520 Park East Blvd., New Albany, IN 47150 U.S.A (812)-944-6733 / 1-800-SAMTEC9

1. ECN #: 240355

- USB USB
- USBR USB TYPE A CONNECTOR

Adding heat stake process to secure surface mount tails.

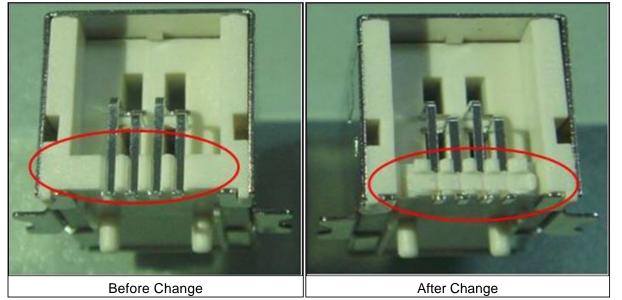
Backend geometry of plastic body changed as shown.

Improve co-planarity of the surface mount tails.

• Form - Geometry of the backend plastic body has changed due to the heat stake process.
